PLANNING COMMISSION REGULAR MEETING

MONDAY, JULY 6, 2026

- a. Adragna - Minor Development Final Plat - Project File: SB2024-030. **4821**
Carolyn Washee-Freeland, AICP, Senior Planner — *Department of Community Development*

Date: June 22, 2026
To: Douglas County Planning Commission
From: Carolyn Washee-Freeland, AICP, Senior Planner *CWF*
Brett Thomas, AICP, Planning Manager *BT*
Steven E. Koster, AICP, Deputy Director of Community Development *SK*
Subject: Adragna – Minor Development Final Plat
Project File: SB2024-030

MINOR SUBDIVISION
 ADRAGNA MINOR DEVELOPMENT
 JOB NO. 23022
 DATE: SEPTEMBER 13, 2023
 SHEET 1 OF 2

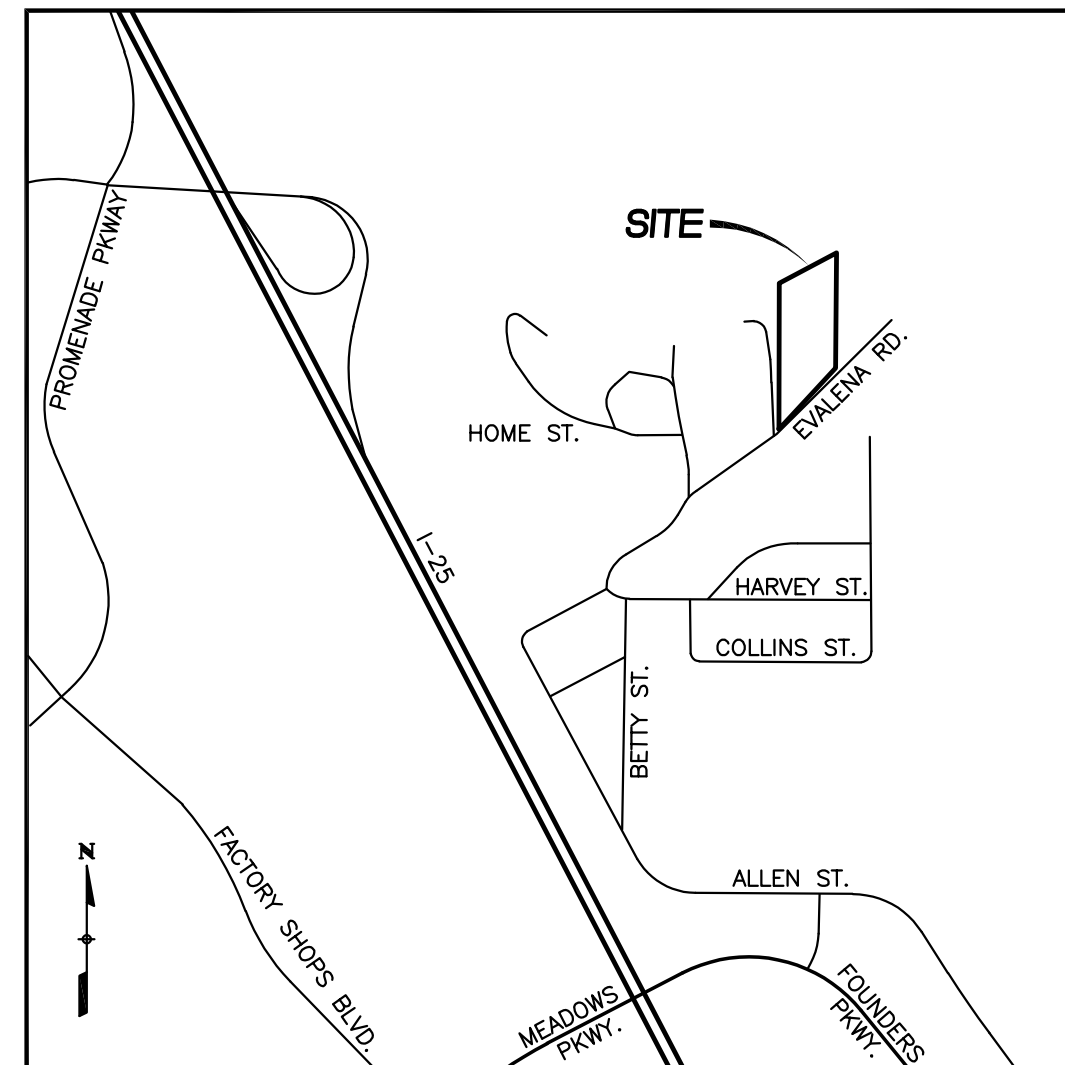
ADD UTILITY EASEMENT DEDICATION LANGUAGE.

Exhibit 3. Geologic hazard map for 1161 Evalena Road designated with the blue star. The property is within a rockfall hazard zone.

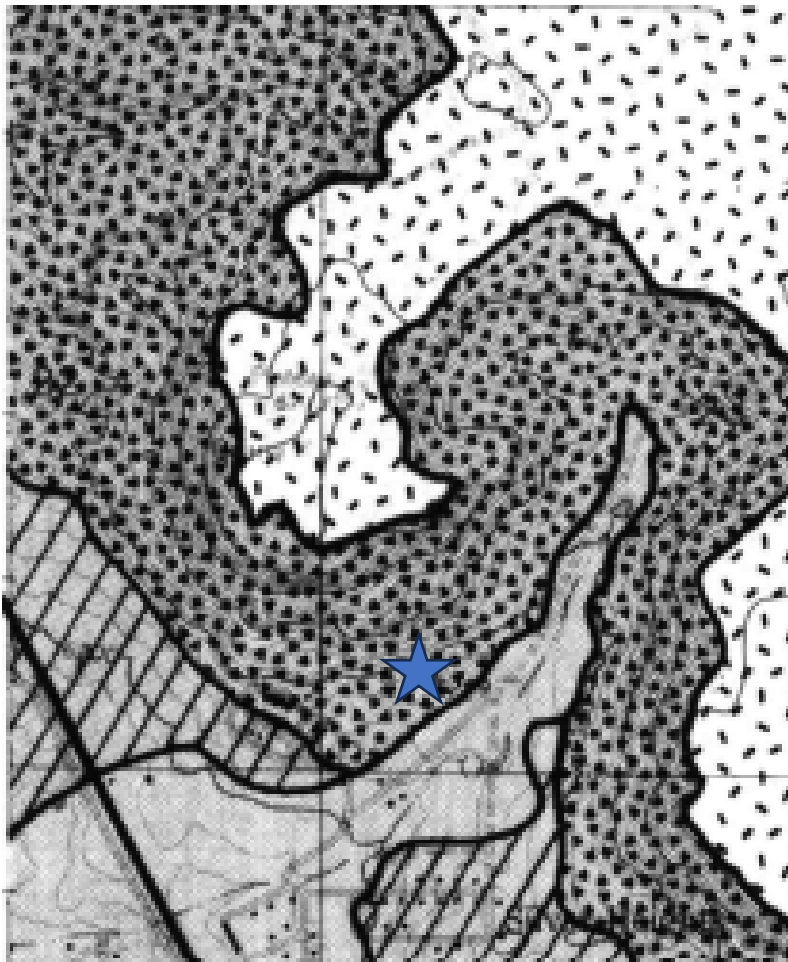
We recommend that the proposed structures be constructed beyond a minimum setback distance of 100 feet from the northern property line, and 50 feet south and west of the centerline of the existing swale that is present in the northmost portion of the site, as shown in Figure 2C. The swale will provide a natural barrier or catchment area for rockfall.

Avoidance is the preferred mitigation method for rockfall and other geologic hazards.
